AMENDMENTS TO THE DRAWINGS:

REMARKS

FIG 3

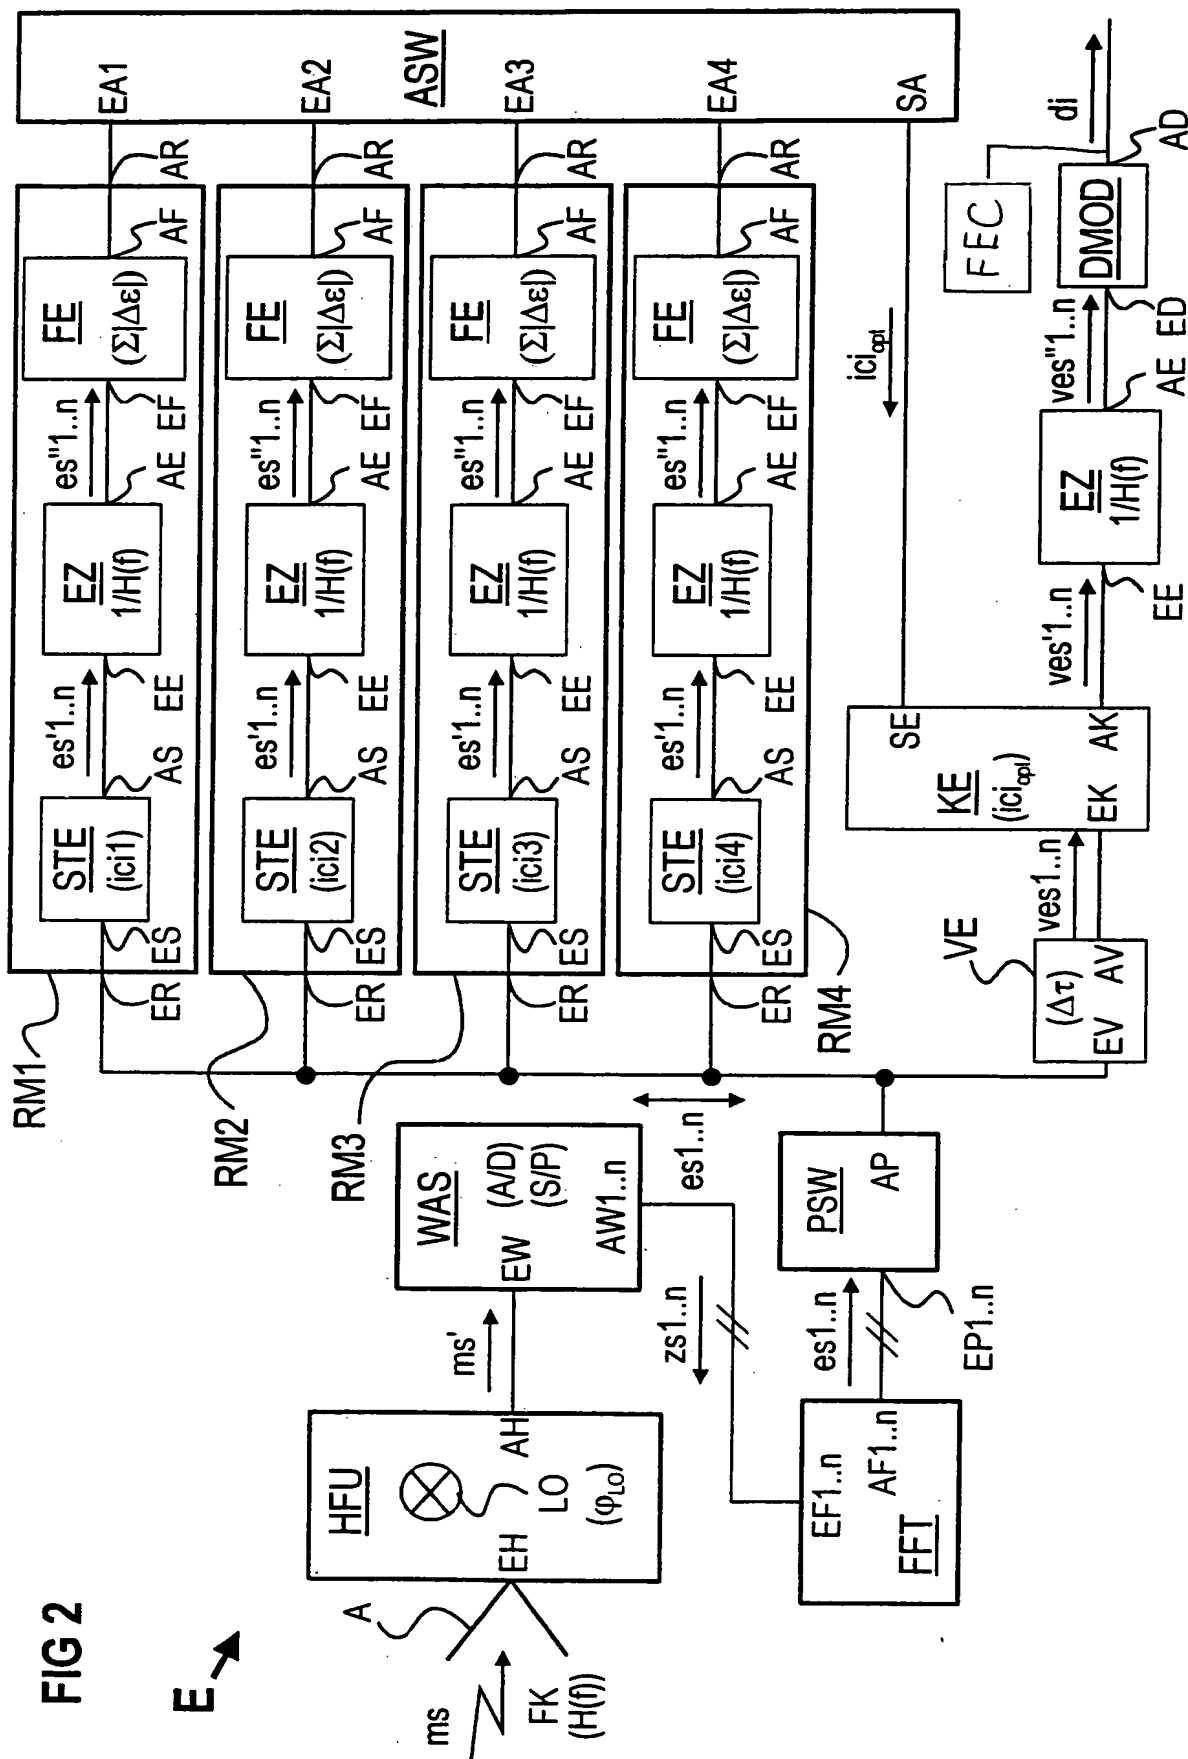
As required on page 4, FIG. 3 has been amended to conform to paragraph [0029] and FIG. 4 has been amended to use the English translation of "Störung."

On page 4 of the Office Action, additional objections were made to Figs. 3 and 4. Figs. 3 and 4 have been amended as required in these objections.
